# Report of the Bulletins and Orders Task Force

Appendices

NUREG-0645

Volume II

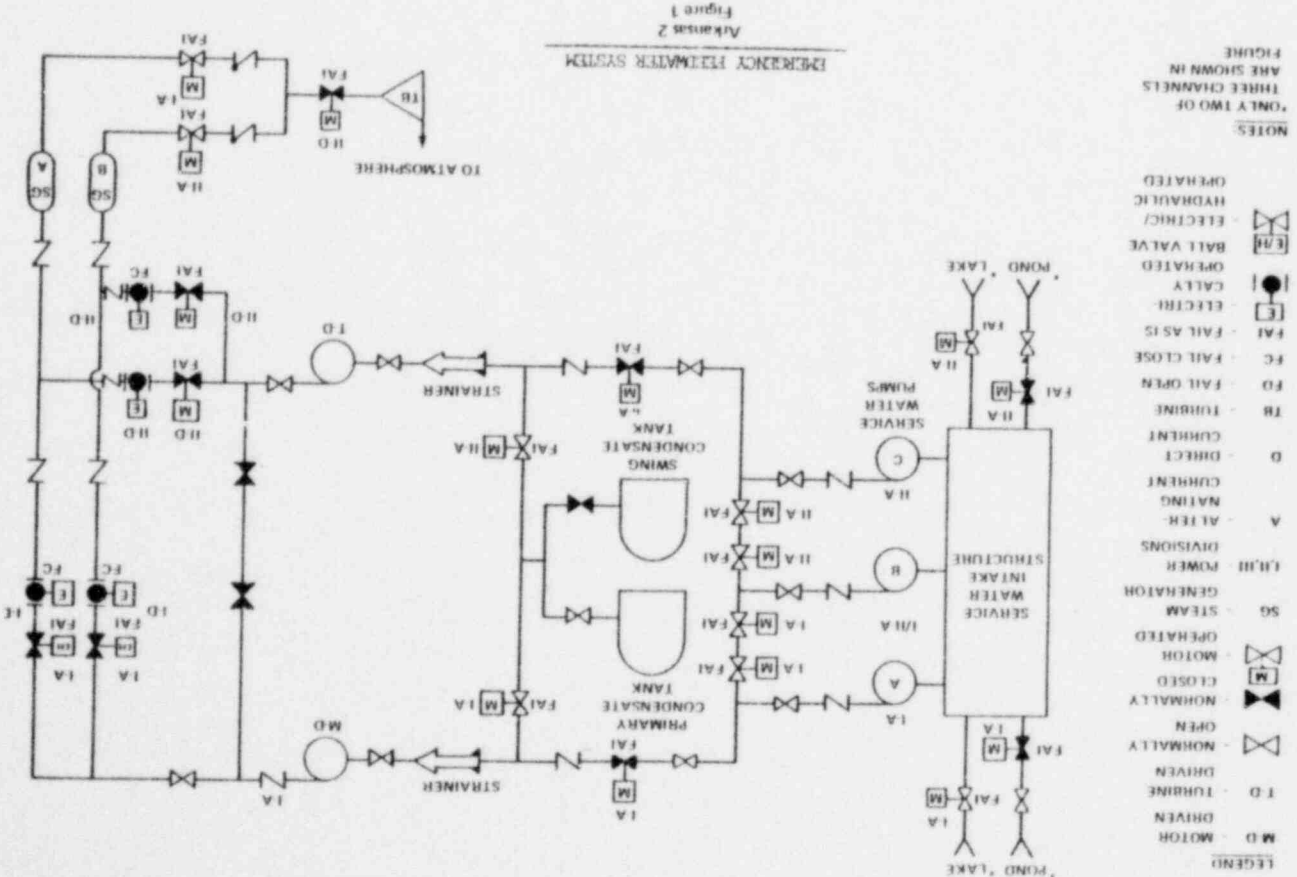
5. Recommendations - The licensee should evaluate the following concerns:
  - a) The AFW pump discharge lines and turbine driven AFW steam supply lines combine into different single lines through which all AFW water or steam must flow. (See Figure 1). A pipe break in either of these single flow paths would cause loss of the entire AFW function.

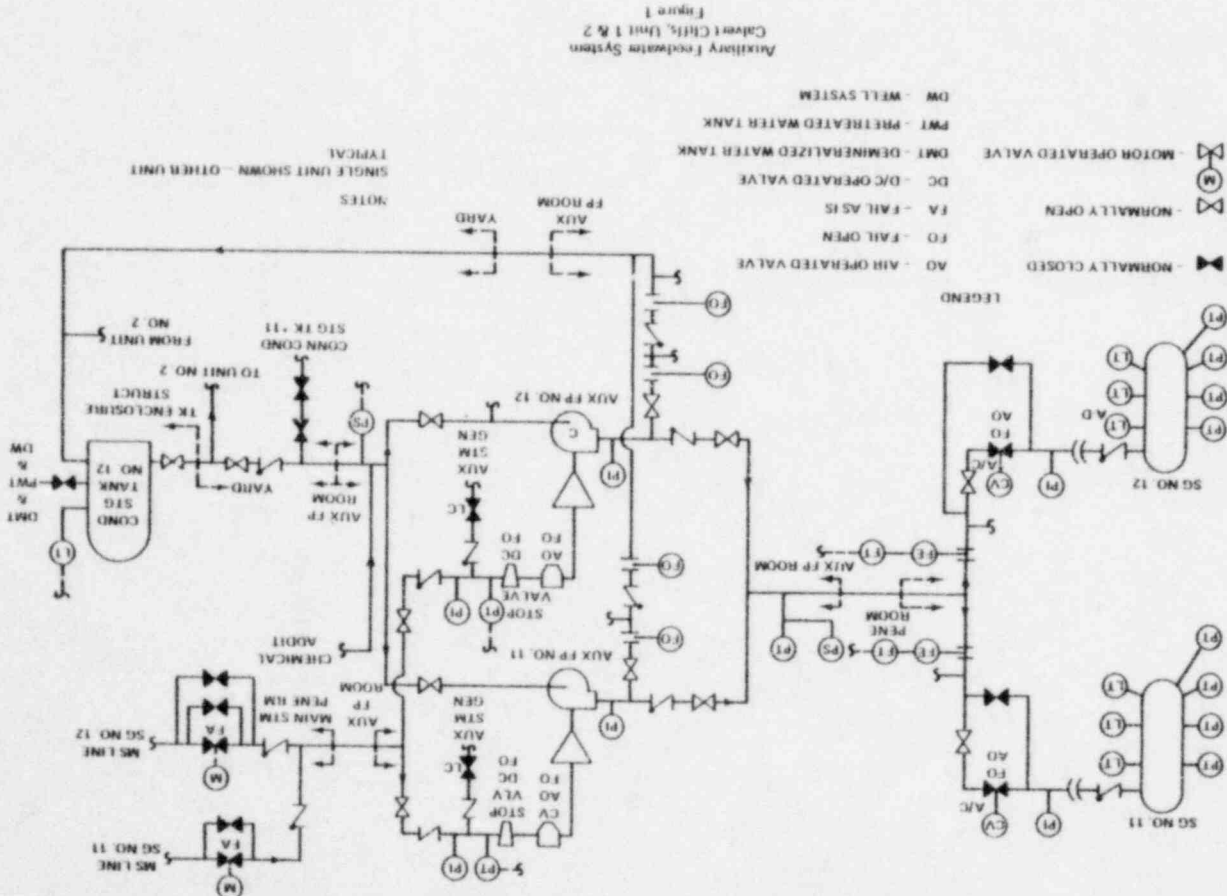
6. Since valves FW 744 and 745 in one of the AFW pump discharge headers are normally open (see Figure 1), a postulated break in this header would cause loss of the capability to provide AFW flow to both steam generators. The licensee should re-evaluate the position of these valves considering such a postulated pipe break to revise the valve alignment to reduce the impact of such an event on the AFW capability (e.g., close valves FW 744 and FW 745).

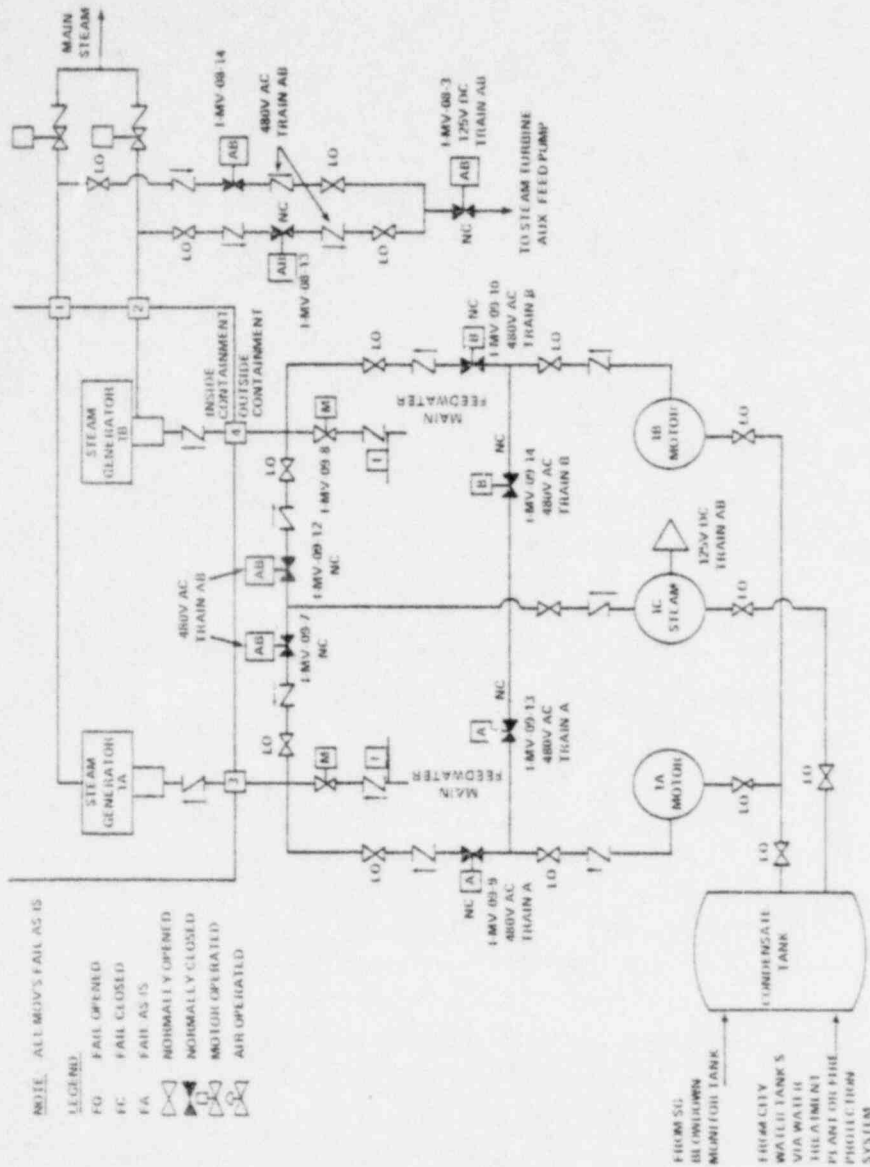
7. Recommendation - As shown in Figure 1, the locked block valves in each AFW pump discharge line are aligned so that the combined flow from one motor-driven pump plus one turbine-driven pump is supplied to the steam generators via one AFW header while flow from the remaining motor-driven pump is supplied to the steam generators via the redundant AFW header. As indicated in Section 1.1.1, the licensee states that in the event of an unisolable main steam or main feed line break, the flow from both motor-driven pumps or from the turbine-driven pump is required to prevent dryout of the steam generators. The licensee should review the present alignment of the AFW pump discharge block valves and modify as necessary to provide the AFW required for normal, transient, and accident conditions.

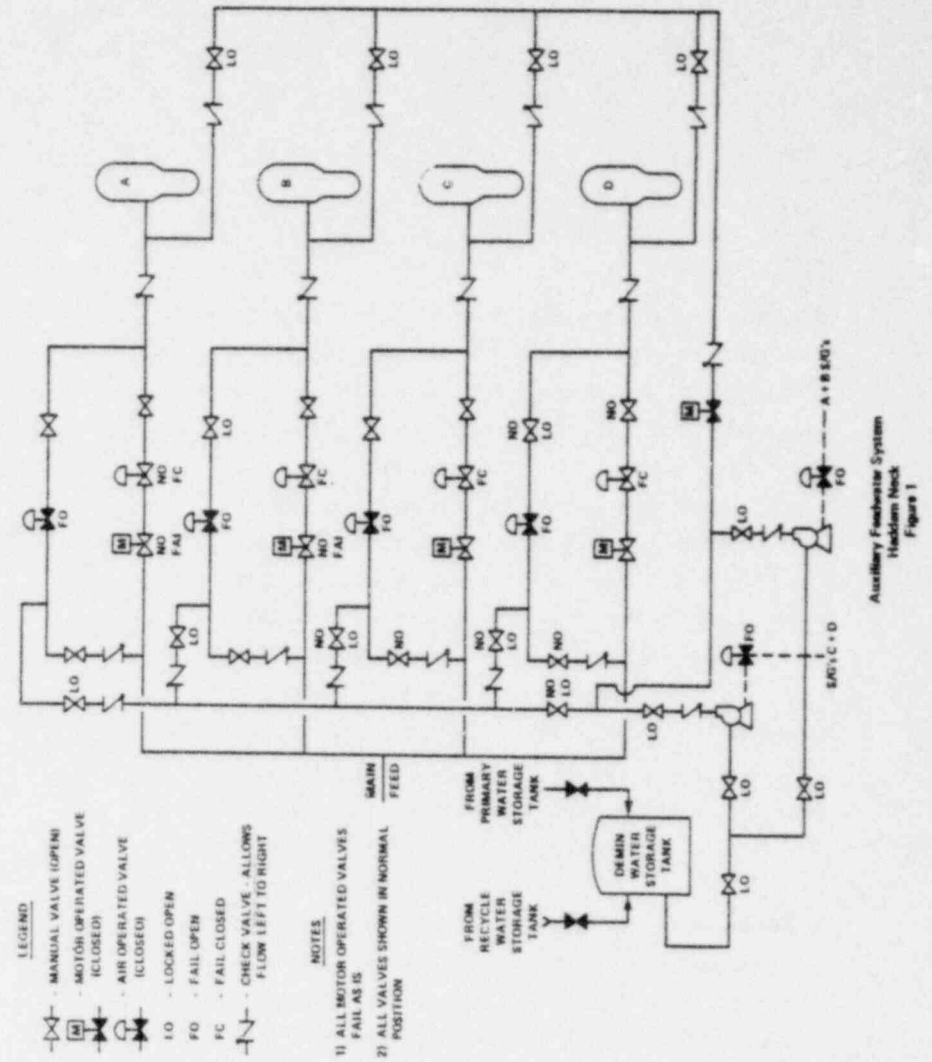
2. Recommendation- GL-5 - The licensee should upgrade the AFW system automatic initiation signals and circuits to meet safety-grade requirements.
3. Recommendation - There is a common crossconnect line with no isolation valves between the two parallel flow paths on the S/G's. A break in this section cannot be isolated in the present design and the total system would be unavailable. It is recommended that some modifications be made (such as isolation valves) to provide isolation when necessary and assure a means of supplying AFW flow following isolation of such a break. The licensee has begun design plans to add a motor driven pump to the system. The licensee should introduce the flow from this third pump in such a manner that a break in this crossconnect

line will not result in the loss of all pumps. Also the licensee should 1) install the third pump with appropriate valves in the pump discharge line connections to meet the high energy line break criteria in SRP 10.4.9 and Branch Technical Position ASB 10-1; namely, to maintain the capability to supply the required AFW flow to the steam generators with a postulated pipe break anywhere in the AFW pump discharge lines plus a single active failure, or 2) describe how the plant can be brought to a safe shutdown condition by use of other available systems following such a postulated event.

Indian Point 2  
Auxiliary Feedwater System  
Figure 1

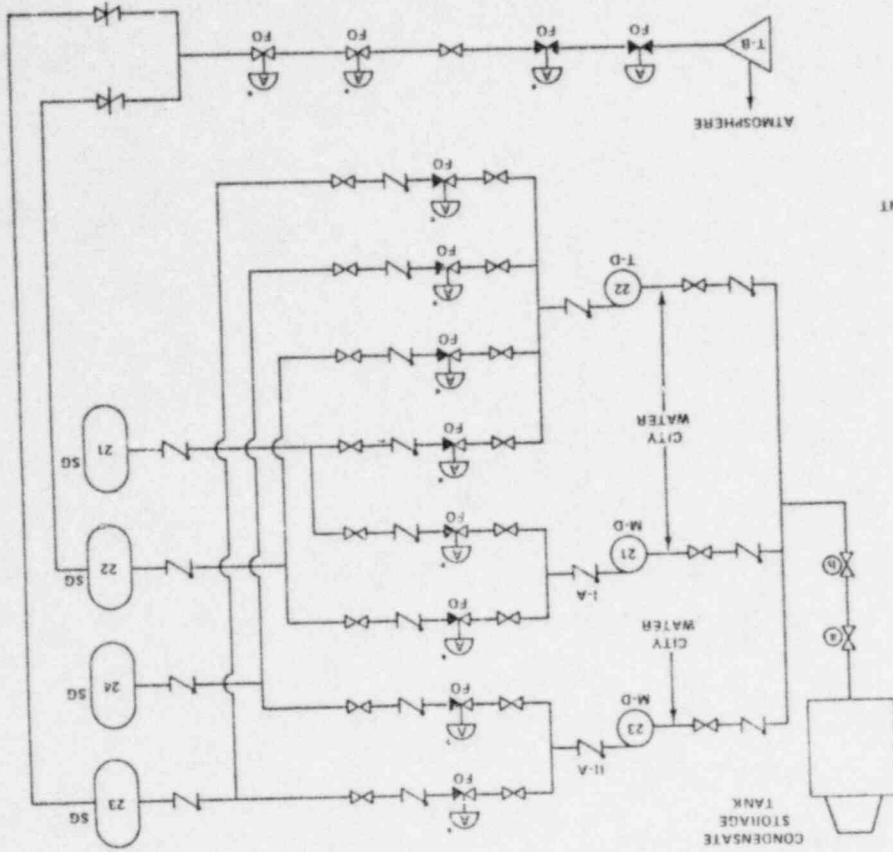
2. Recommendation GL-5 - The licensee should upgrade the AFW system automatic initiation signals and circuits to meet safety-grade requirements.
3. Recommendation - The two motor-driven pumps and the turbine driven pump are located in the same room. The licensee should evaluate the capability of the design to withstand a) environmental conditions (steam, flooding, pipe whip and jet impingement) resulting from a pipe break, b) internally generated missiles.

The licensee should evaluate the postulated pipe breaks stated above and (1) determine any AFW system design changes or procedures necessary to detect and isolate the break and direct the required feedwater flow to the steam generator(s) before they solidify or (2) describe how the plant can be brought to a safe shutdown condition by use of other systems which would be available following such postulated events.

Auxiliary Feedwater System  
Indian Point-2

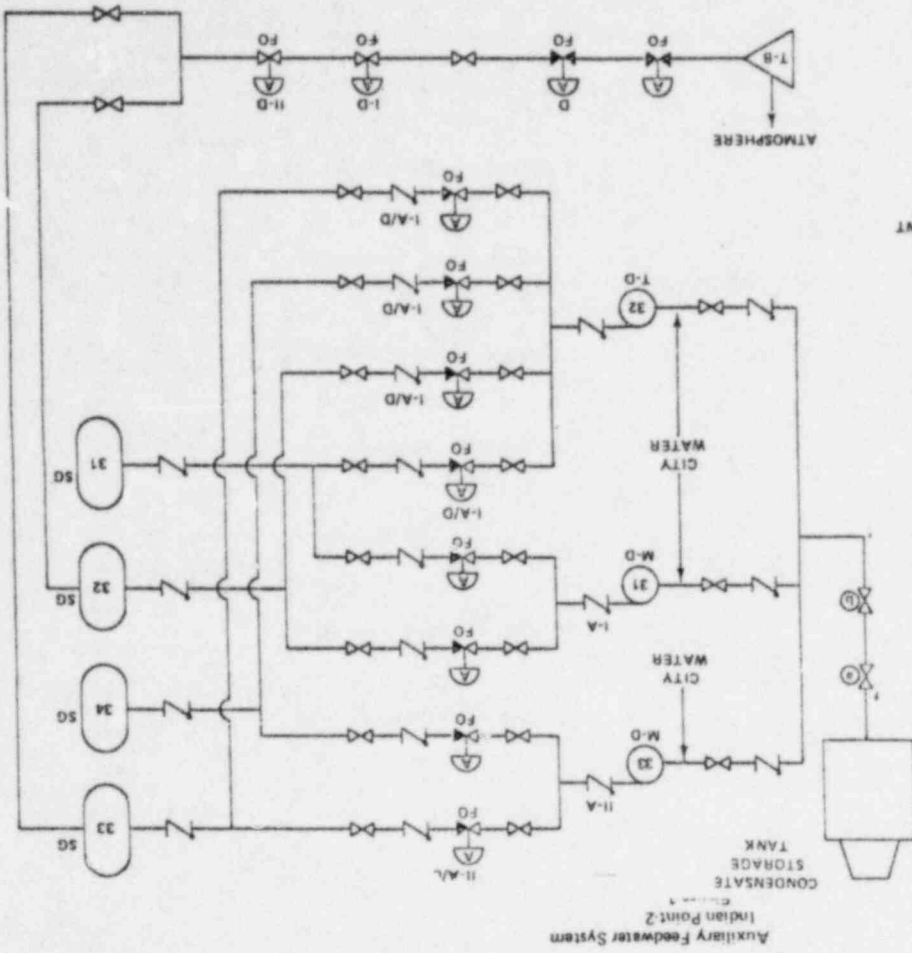
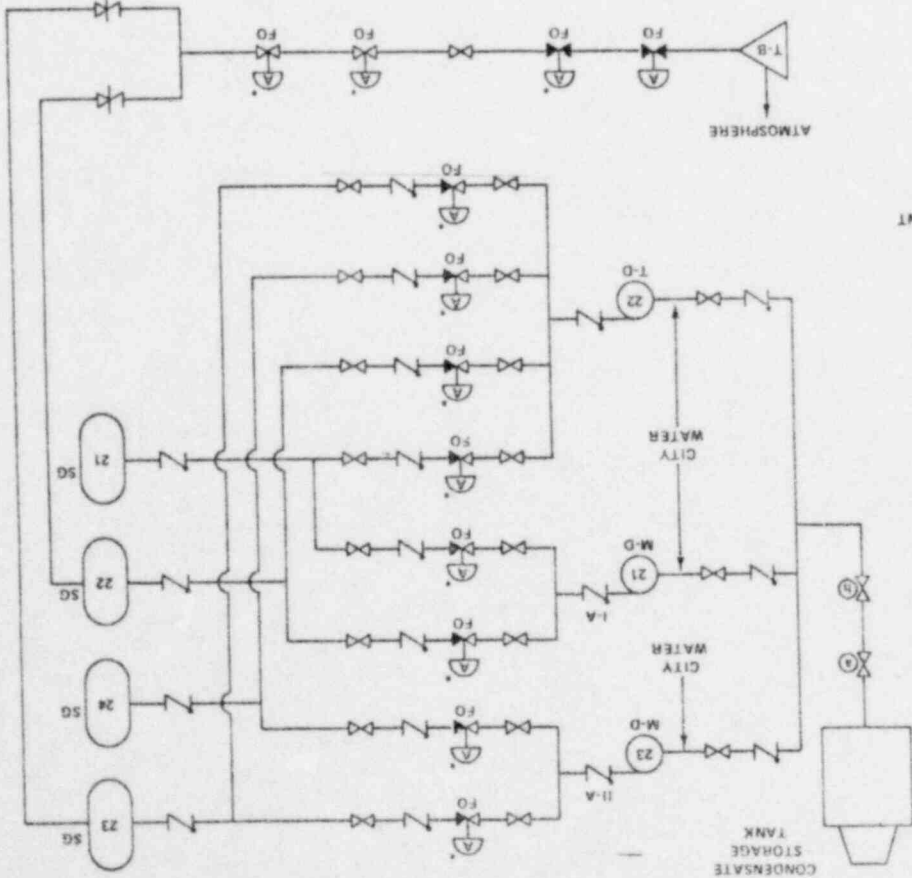
2. Recommendation GL-5 - The licensee should upgrade the AFW system automatic initiation signals and circuits to meet safety-grade requirements.
3. Recommendation - The two motor-driven pumps and the turbine driven pump are located in the same room. The licensee should evaluate the capability of the design to withstand a) environmental conditions (steam, flooding, pipe whip and jet impingement) resulting from a pipe break, b) internally generated missiles.

The licensee should evaluate the postulated pipe breaks stated above and (1) determine any AFW system design changes or procedures necessary to detect and isolate the break and direct the required feedwater flow to the steam generator(s) before they boil dry or (2) describe how the plant can be brought to a safe shutdown condition by use of other systems which would be available following such postulated events.
